Interactive comment on “Hydraulic fracturing in thick shale basins: problems in identifying faults in the Bowland and Weald Basins, UK” by David K. Smythe

A. Kingdon

DISCUSSION OF FAULTS AND EARTHQUAKES IN THE VICINITY OF THE PREESE HALL WELL

Fig. 1.

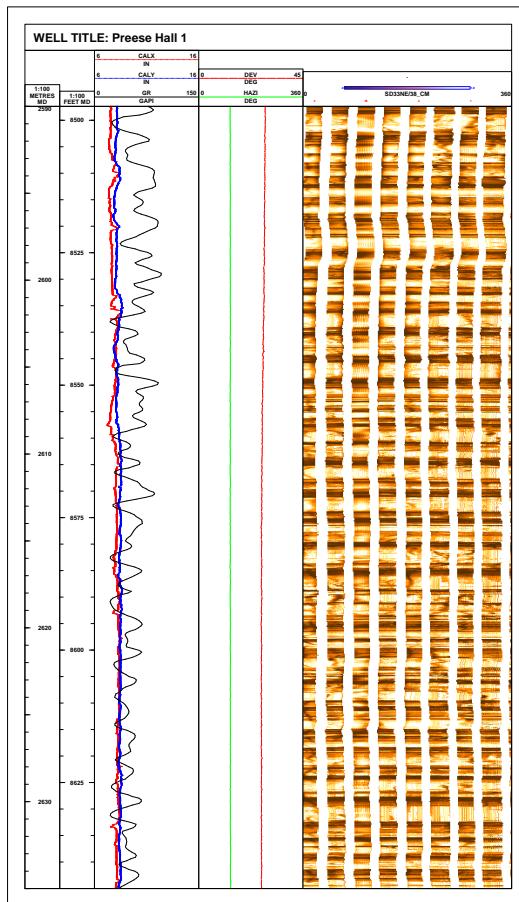
ence of the borehole wall. This technique dates in primitive form (borehole camera and televIEWERS) from the 1960s and has been extensively applied to well interpretations and published on since. Resistivity borehole imaging data was collected by Weatherford using their CMI tool for an extensive interval of the Preese Hall well. The imaging data collected in the Preese Hall well are of high quality providing a clear view of the state of the borehole wall. The original De Pater and Baisch report includes figures showing a number of sections of borehole imaging. Their Figure 31, which highlights the borehole ovalisation, includes interpreted dip data directly derived from the CMI imaging tool; this figure is included in Smythe's paper (his version included as figure 6), though with this dip data omitted. Therefore the author must have been aware of the availability of this borehole imaging data. (As the author describes in section 2) Data for all UK hydrocarbon wells are available from DECC appointed data release agents. Data typically includes composite plots, conventional geophysical logs and well data reports; Preese Hall data was released in April 2015. It would therefore have removed ambiguity from the author's interpretations if he had chosen to publish this original data, rather than reusing other author's figures. Examination of the borehole imaging for Preese Hall, collected prior to the fracking operation, showed unambiguous evidence of faults in this borehole in other sections of the well (for example at 2015 mbKB / 6613 fbkb showing a 40cm displacement fault). However, borehole imaging in the interval 8500 to 8640' shows consistent low angle bedding but no evidence of a fault intersection. The author could have accessed the borehole imaging data as it was available from release agents with all other data during April 2015. (IHS 2016, personal communication). It is unfortunate that the author chose not to examine the borehole imaging as this shows without ambiguity that his hypothesised fault does not intersect the wellbore in this interval.

The borehole imaging from Preese Hall well shows that Smythe's interpreted fault is not present. Given that a key element of his hypothesis can be disproven using freely available data I would recommend that this version of this paper should be withdrawn from publication by the author.
